Maule Aircraft Corporation

Service Letter #21

Subject: Bucket Seats

Models: M-4-180C and M-4-220C Series Aircraft

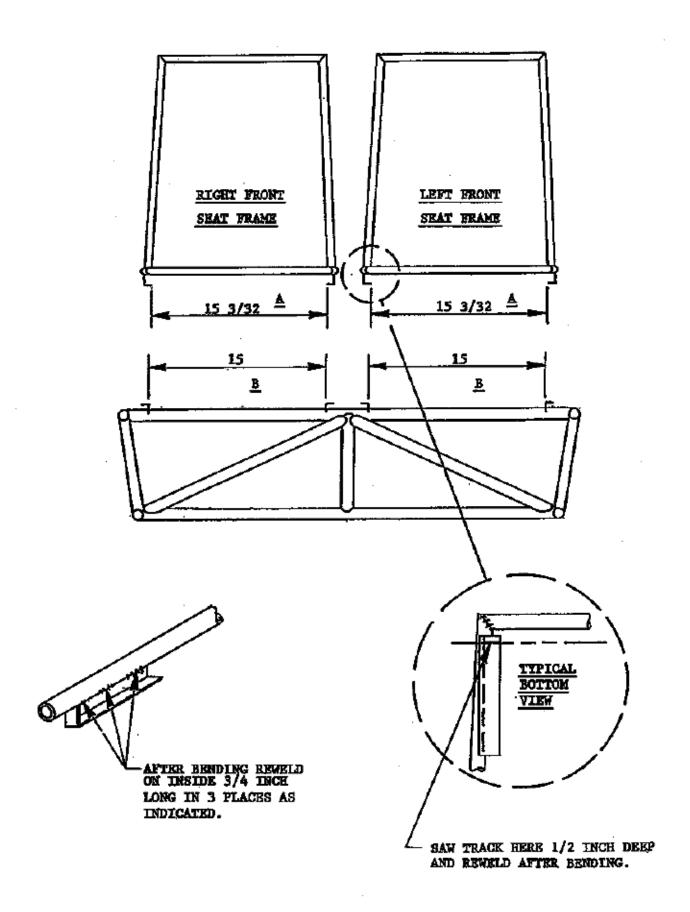
We have discovered that there is a possibility that the bucket seats can come out of track.

It is mandatory that this service letter be accomplished before the next flight.

- 1. Remove seats.
- 2. Measure distances "A" & "B" as shown on drawing (Page 3).
- 3. If distance of "A" is not more than 3/32" longer than "B", the track is considered to be satisfactory.
- 4. If "A" is greater than "B" by more than 8/32", repair must be made by bending track in the proper amount. There must be at least 5/32" catch in the track when seat is shifted to one side as far as possible.
- 5. Bending track may be accomplished by using an 8" creasent wrench sliding it over the track and using a small block at the end of the jaw to block it out of the width of the track. The track must be out adjacent to the end plate to permit bending.
- 6. Reweld track as per drawing, on page 3, using electric or acetylene welder.
